REF: 23/00977/OUT

Location: OS Parcel 9195 North Of Claydon Road
Cropredy

Holding objection

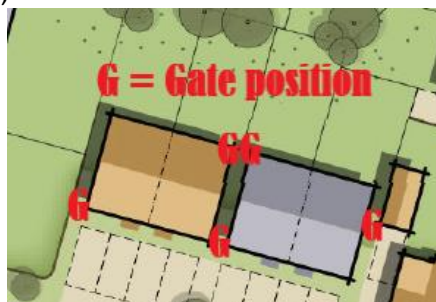
- I assume the below diagram illustrates double garages to the rear of two dwellings. This proposal is objectionable, as both the vehicles on the drive and garages would be at high risk of crime due to complete lack of surveillance. The house/garden alignment of these two plots also restricts the surveillance opportunities that these important corner plots provide. I recommend dwellings sit in line with, or proud of their garden boundary, allowing wider surveillance/views over the public realm. This proposed arrangement also provides a long section of dead frontage, significantly reducing surveillance over the public realm and open space. For the same reason, FOGs would not be appropriate in this location due to the lack of active frontage at ground floor level. This section of the development facing onto large swathes of POS must be designed to provide active frontage from as many dwellings as possible to maximise surveillance over the public space. Also see guidance below regarding parking to the rear of a dwelling.
